Product Change Notification

113595 - 00

Change Notification #: 113595 - 00
Change Title: Intel® Server System R1208GZ4GS9
PCN 113595-00, Product Design
Update the System Rear Panel and
BIOS/ME/BMC/FRUSDR Firmware
Date of Publication: January 23, 2015

Figure One

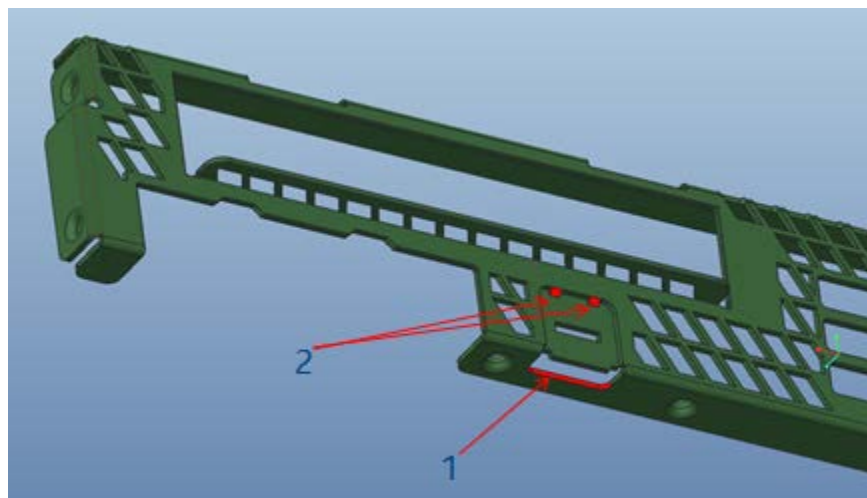
1. Add a connection at the bottom of the RMM4 (Remote Management Module 4) slot to improve structure strength. See item 1 in the Figure One.
2. Update the one big center joint to two smaller joints so that the joints will not conflict with the LAN cable connector latch. See item 2 in Figure One.

Figure Three

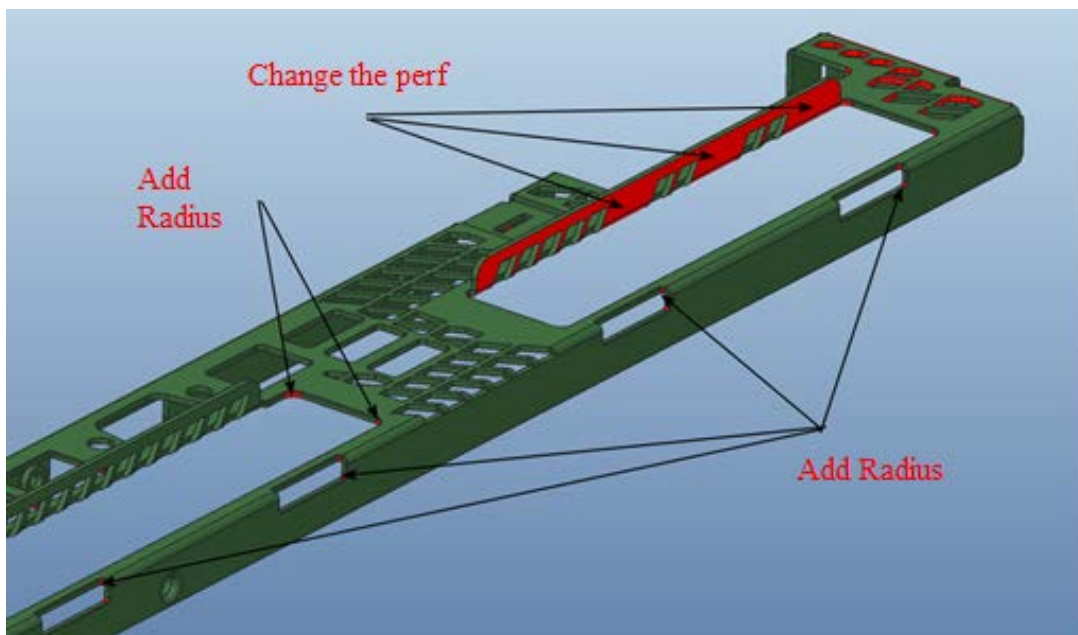
4. Update the perf and add radius to improve structure strength. See Figure Three and Four.

Figure Five

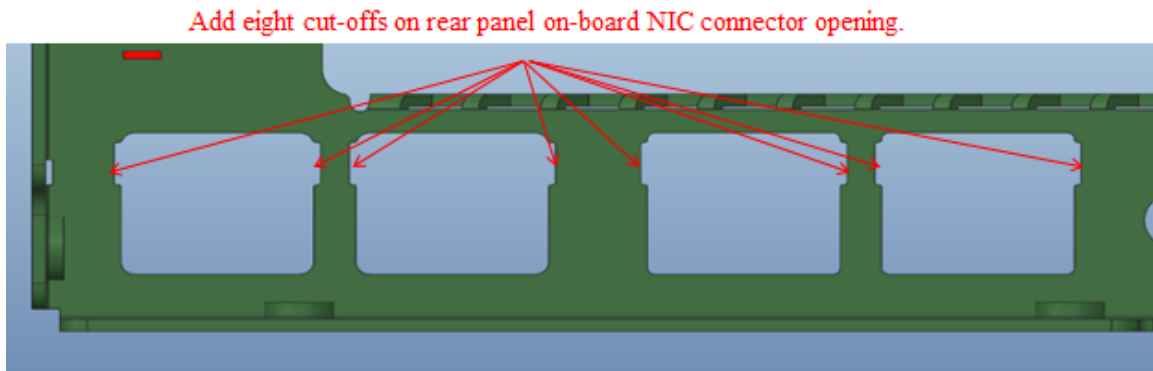
5. Add eight cut-offs around the on-board NIC (Network Interface Controller) openings to improve the LED visibility. See Figure Five.
